**PLANNED UNIT DEVELOPMENT
& SUBDIVISION STAFF REPORT**

Date: October 17, 2019

Sherman Oaks on the Hill Subdivision

3600 Spring Hill Avenue
(North side of Spring Hill Avenue, 105'± West of Mann Drive)

SITE PLAN

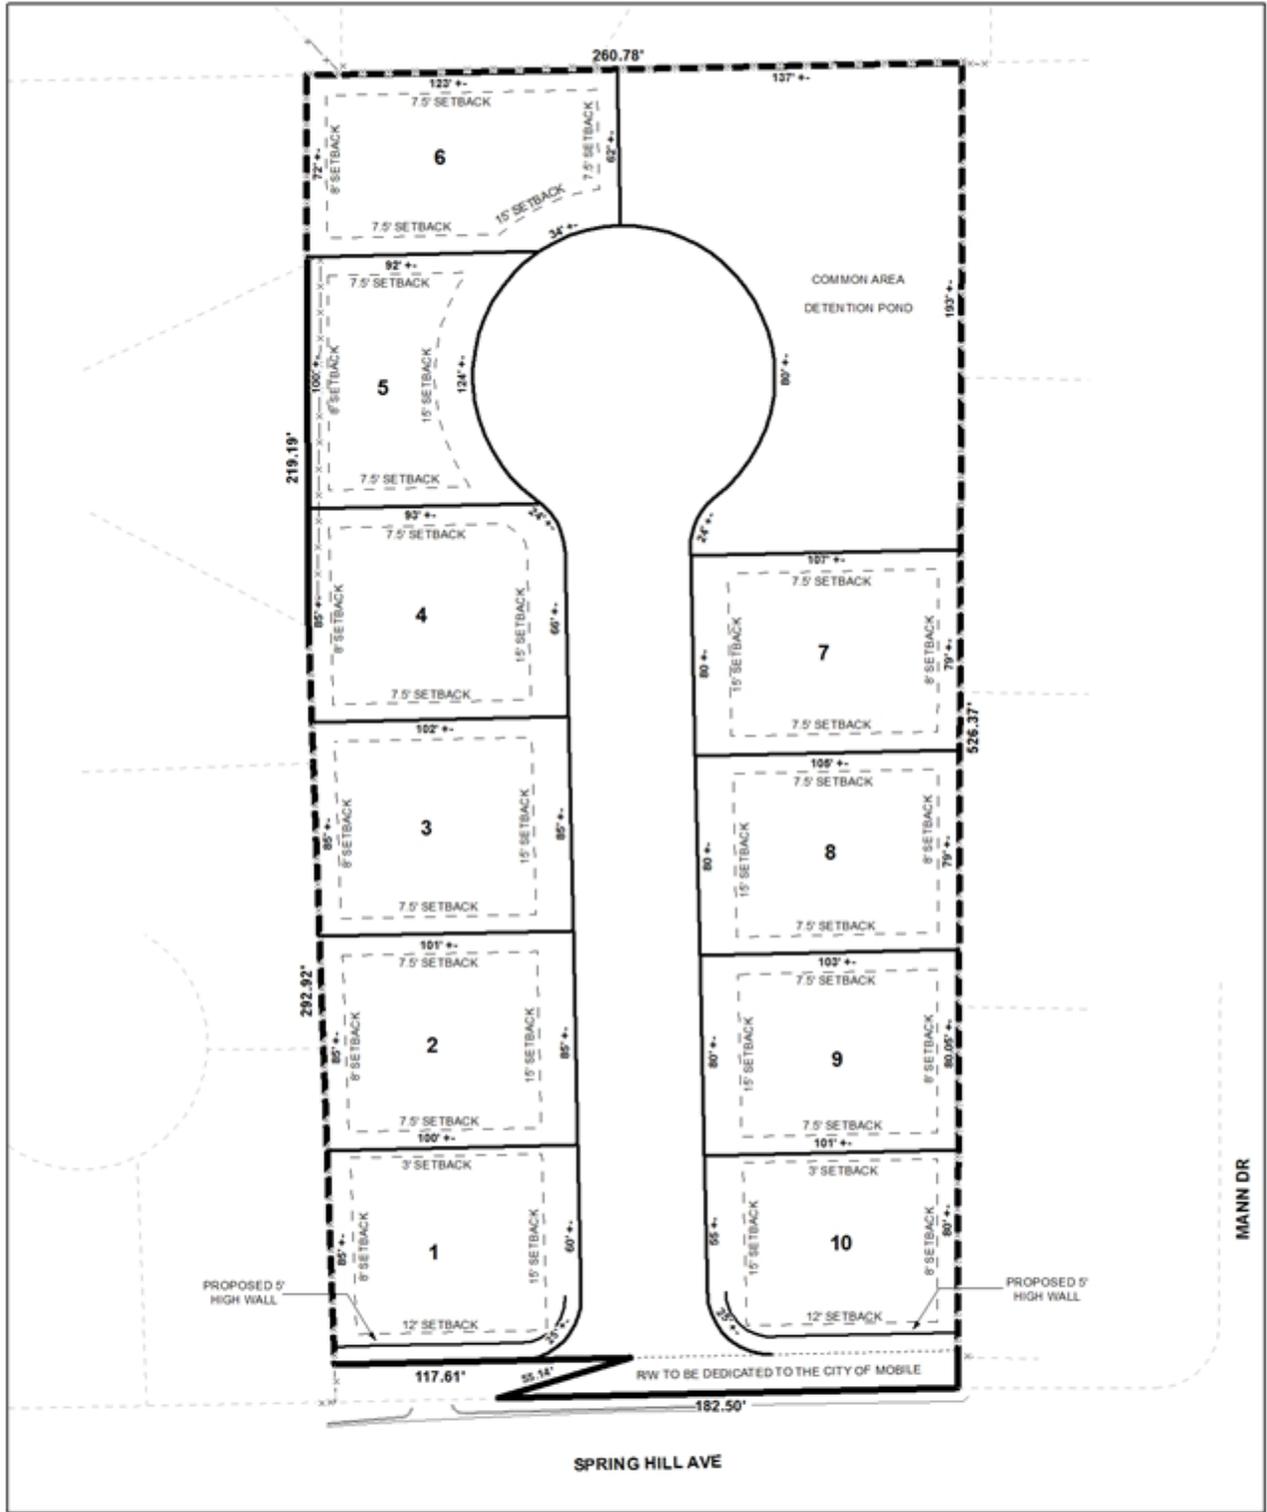
- B. Provide and label the monument set or found at each subdivision corner, including the new lots.
- C. Add Mann Drive to the vicinity map.
- D. Provide the geometric data for the proposed cul-de-sac.

- E. Based on the proposed ROW dedication label the remaining private drive as PRIVATE or COMMON AREA.
- F. Provide a bearing and distance for the northern leg of the proposed public ROW dedication along Spring Hill Ave.

- G. Provide the acreage of the proposed ROW dedication along Spring Hill Ave.
- H. Add a signature block for the Owner, Notary Public, Planning Commission, Traffic Engineer, and City Engineer.

- J. Provide the Surveyor's, Owner's (notarized), Planning Commission, and Traffic Engineering signatures.
- K. Provide adequate drainage easements, if needed, for the outfall from the proposed detention pond.

- 6) revision of the plat to dimension the wall setback from the Spring Hill Avenue right-of-way line;
- 7) compliance with the Engineering comments: *[FINAL PLAT COMMENTS (should be addressed prior to submitting the FINAL PLAT for review and/or signature by the City Engineer): A. Provide all of the required information on the SUBDIVISION PLAT (i.e. signature blocks, signatures, certification statements, written legal description, required notes, legend, scale, bearings and distances) that is required by the current Alabama State Board of Licensure for Professional Engineers and Land Surveyors. B. Provide and label the monument set or found at each subdivision corner, including the new lots. C. Add Mann Drive to the vicinity map. D. Provide the geometric data for the proposed cul-de-sac. E. Based on the proposed ROW dedication label the remaining private drive as PRIVATE or COMMON AREA. F. Provide a bearing and distance for the northern leg of the proposed public ROW dedication along Spring Hill Ave. G. Provide the acreage of the proposed ROW dedication along Spring Hill Ave. H. Add a signature block for the Owner, Notary Public, Planning Commission, Traffic Engineer, and City Engineer. I. Provide the Surveyor's Certificate. J. Provide the Surveyor's, Owner's (notarized), Planning Commission, and Traffic Engineering signatures. K. Provide adequate drainage easements, if needed, for the outfall from the proposed detention pond. L. Add a note to the SUBDIVISION PLAT stating that a Land Disturbance permit will be required for any land disturbing activity in accordance with Mobile City Code, Chapter 17, Storm Water Management and Flood Control); the City of Mobile, Alabama Flood Plain Management Plan (1984); and, the Rules For Erosion and Sedimentation Control and Storm Water Runoff Control. M. Add a note to the Plat stating that the approval of all applicable federal, state, and local agencies (including all storm water runoff, wetland and floodplain requirements) will be required prior to the issuance of a Land Disturbance permit. N. Add a note that sidewalk is required to be constructed, and/or repaired, along the frontage of each lot, or parcel, at time of new development or construction, unless a sidewalk waiver is approved. O. Add a note to the plat stating that all proposed detention facilities, common areas, and wetlands shall be the responsibility of the Property Owner(s), and not the responsibility of the City of Mobile. P. Add a note to the plat stating that all easements shall remain in effect until vacated through the proper Vacation process. Q. Provide a copy of the FINAL SUBDIVISION PLAT to the Engineering Dept. for review. No signatures are required on this drawing. R. After addressing all of the FINAL SUBDIVISION PLAT review comments by the Engineering Dept. provide the red-line markup, the ORIGINAL (with all other signatures) and one (1) copy of the revised original (signatures not required) of the revised Final Plat to the Engineering Department.];*

- 5) placement of a note on the site plan stating that the maintenance of the Common Area/Retention Pond is the responsibility of the property owners;
- 6) revision of the site plan to dimension the wall setback from the Spring Hill Avenue right-of-way line as measured from any required dedication;
